## Town of Nags Head

### Planning & Development Department

Subject: Sketch Plan Review, Sit Down Restaurant, 7100 S. Croatan Highway

Subject: Sketch Plan Review, Starbucks Restaurant, 7100 S. Croatan Highway

**PROPOSED RESTAURANT SKETCH PLAN**

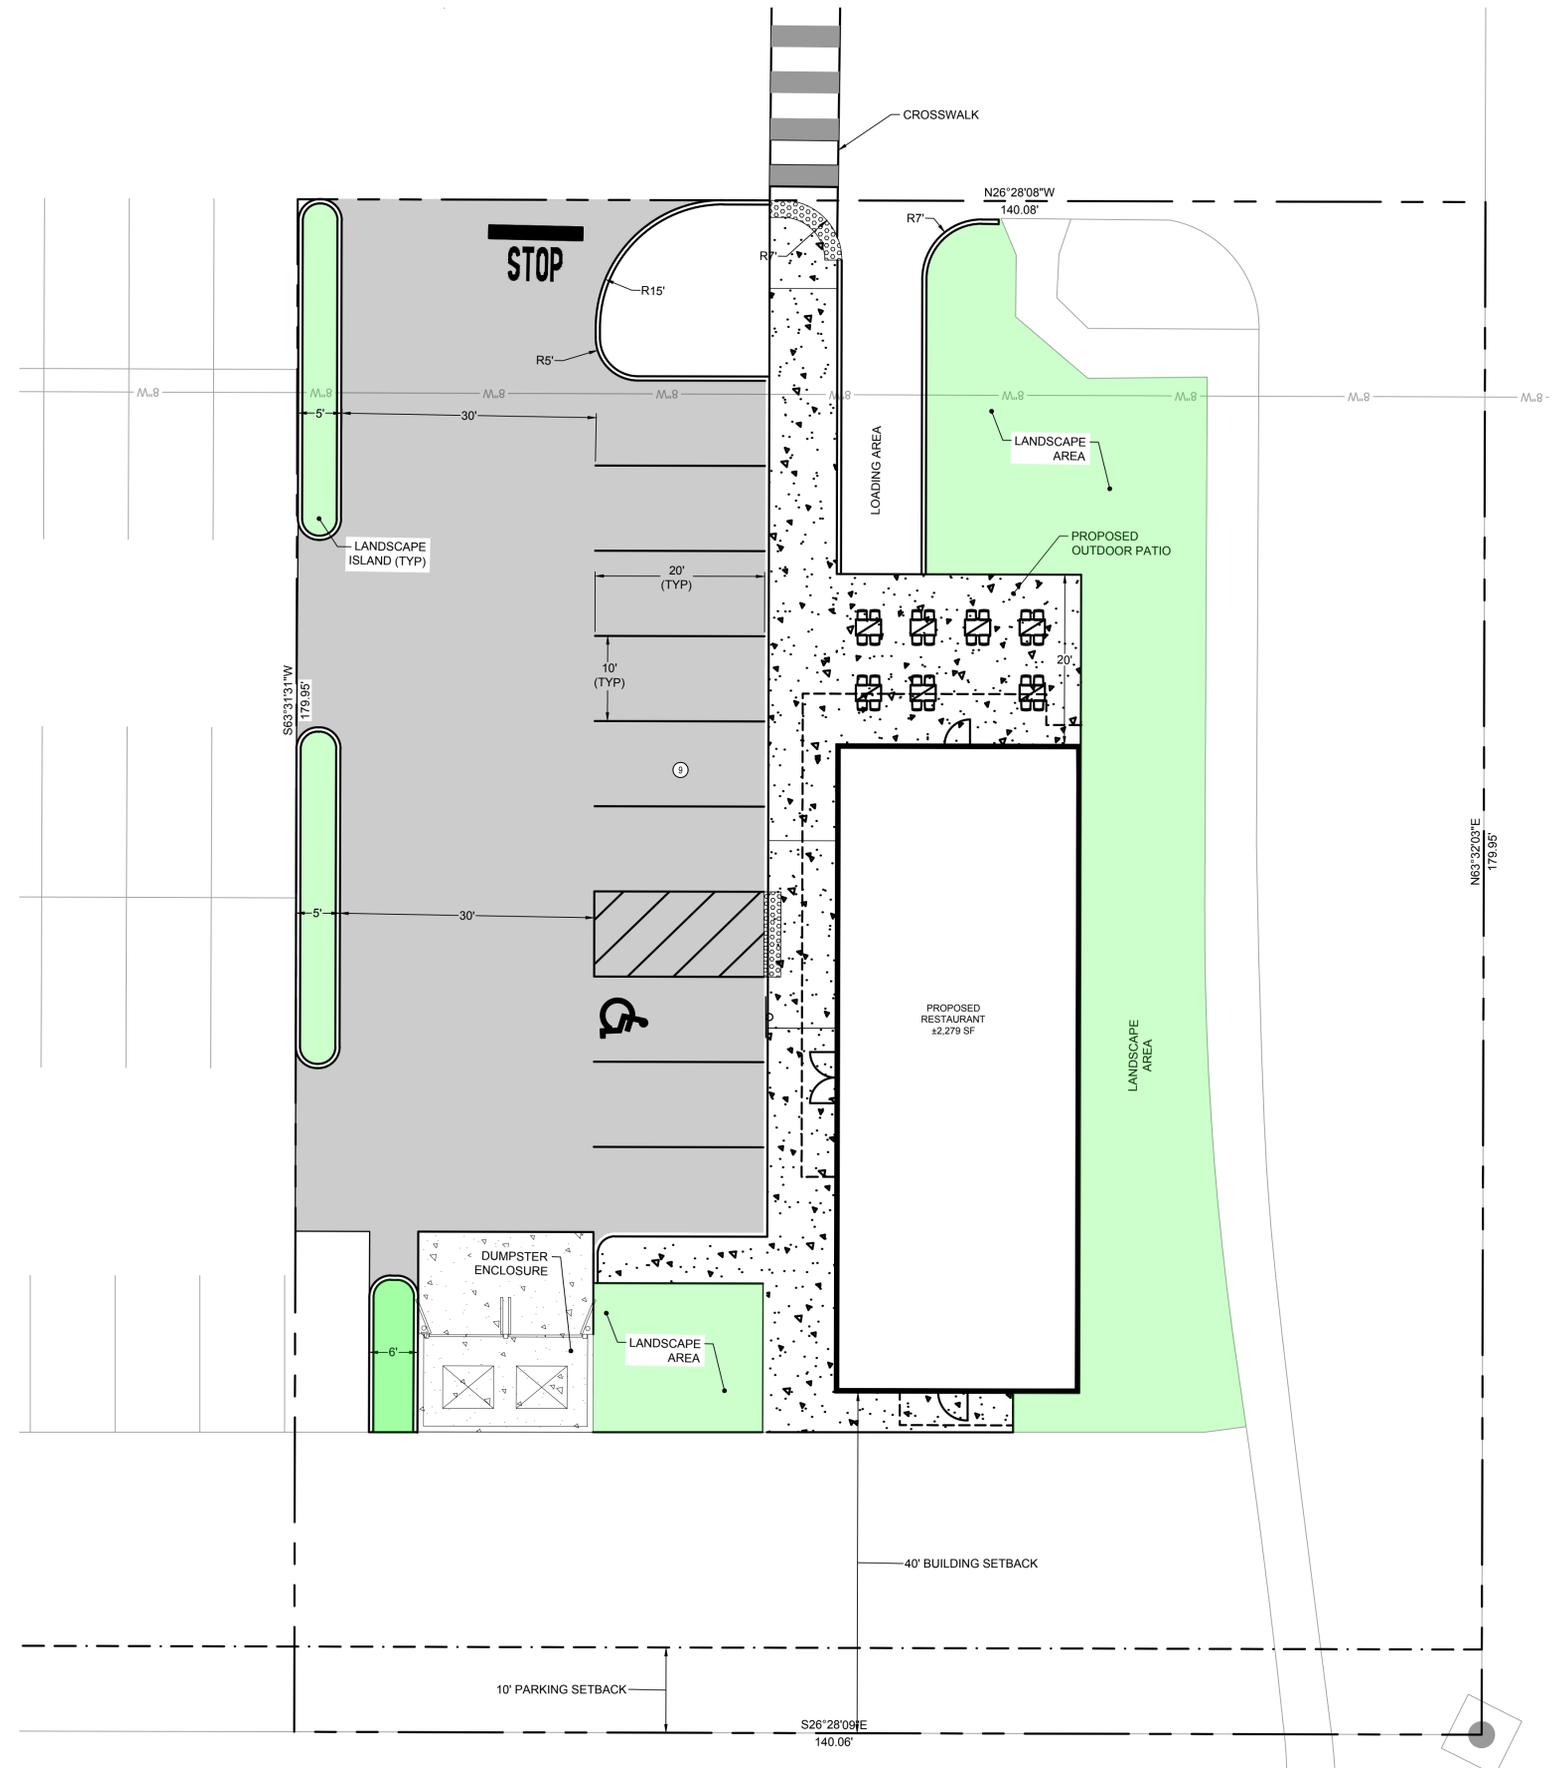
- *Currently, there are 488 parking spaces at Outlets Nags Head. The proposed development would reduce this number by 28 spaces. According to the current parking requirements in the Unified Development Ordinance, a total of 395 parking spaces are needed. While the minimum parking standards for the Shopping Center/Group Development would still be met, there would still be an overall loss of 28 parking spaces.*

- *Although the proposed addition to Outlets Nags Head would meet the minimum parking requirements, it is important to consider that this development is extremely popular during the summer months and in inclement weather, often resulting in full parking facilities. Any reduction in parking at this site could have negative consequences. Until we have more detailed information about the proposed restaurant, a comprehensive analysis of potential parking impacts is difficult to provide.*

- *As proposed at this phase, lot coverage would not be affected. Should this proposal result in any change in coverage, that must be shown.*
- *Compliance with Section 10.92.14.4 of the Unified Development Ordinance, requiring 20% of the surface area of parking area and drive aisles be constructed of permeable materials.*

- *Compliance with Section 10.93.3.7 as it relates to Interior Parking Lot Landscaping.*
- *Account for the location of mechanical equipment in the site plan.*

- *A vehicular pathing exhibit is requested to demonstrate adequacy for turning radius for sanitation vehicles and fire trucks.*
- *Additional information is requested on the restaurant to include type of restaurant (ie fast food, high turnover, etc.) and time of operation to review parking generation for this type of establishment. Currently, the shopping center parking during peak periods is at or near 100% occupancy. This data will be critical in determining impacts both internal and external to the shopping center.*
- *Cross-parking easements may need to be considered if not shopping owner operated.*

- *Ensure that the front load sanitation truck can easily turn into and back out of the entry for dumpster pick up. Pathing exhibit required to ensure turn radius can be met.*

**NAGS HEAD RESTAURANT**  
 BUILDING ELEVATIONS

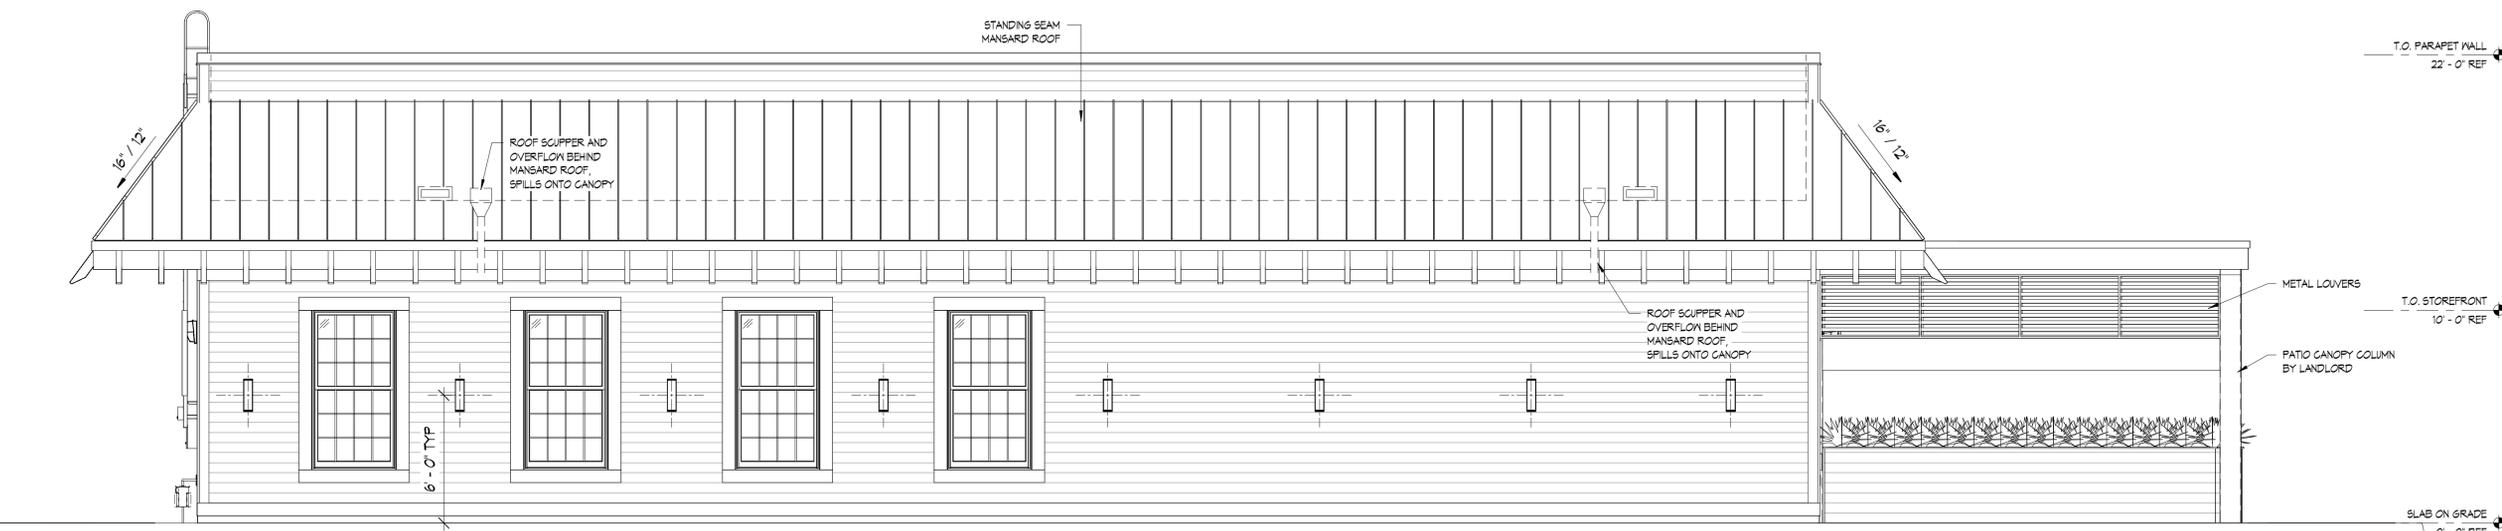
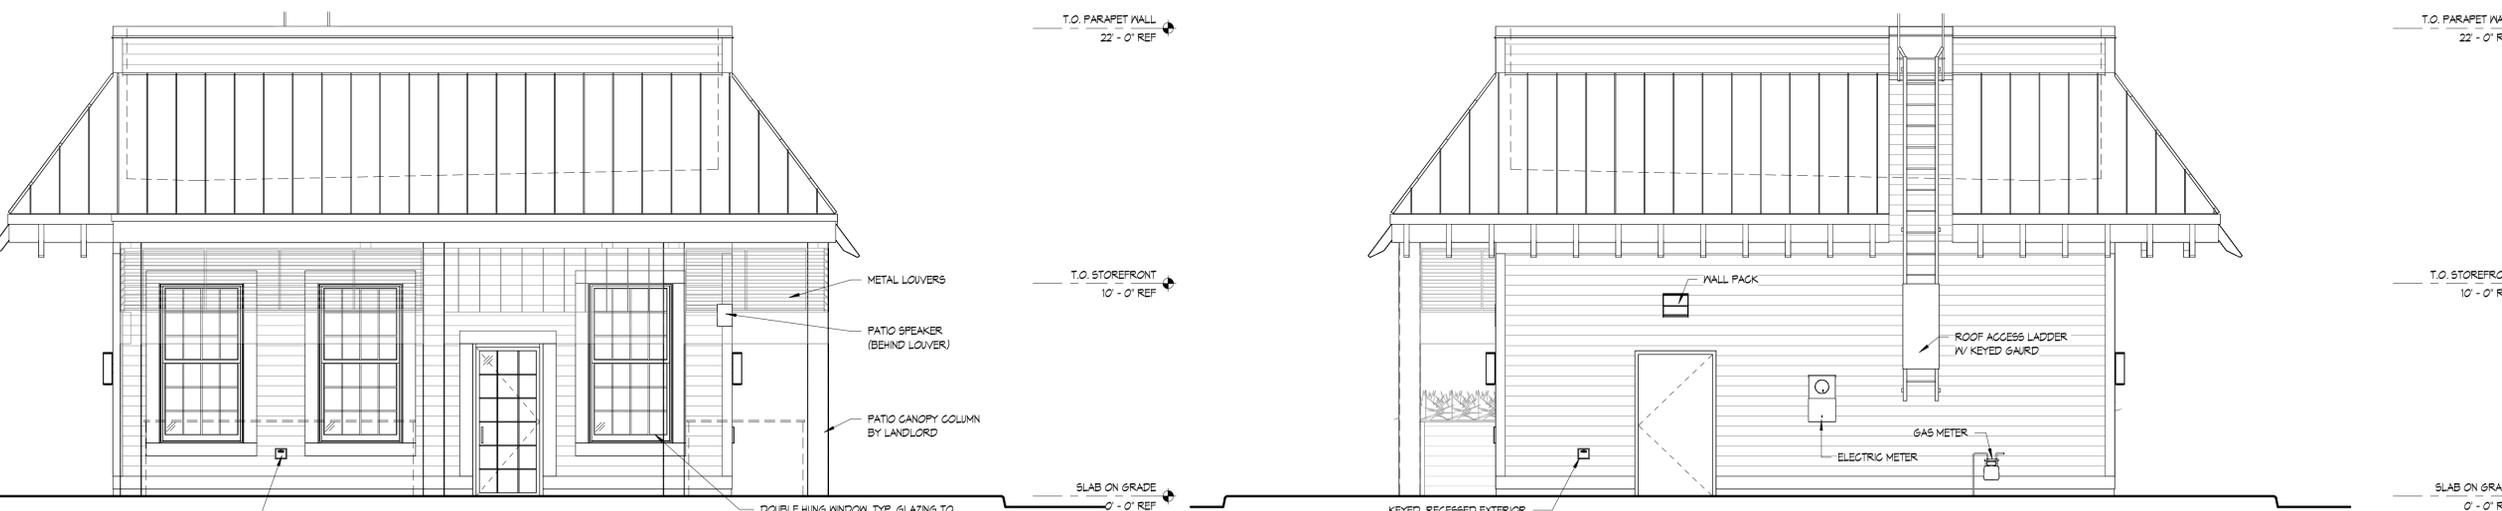
*The conceptual elevations provided in the packet are preliminary and represent the owner's/architect's initial design. Prior to the next Technical Review Committee Meeting and formal Planning Board Site Plan Review submittal, compliance with Article 10, Part VI, Commercial Design Standards must be demonstrated.*
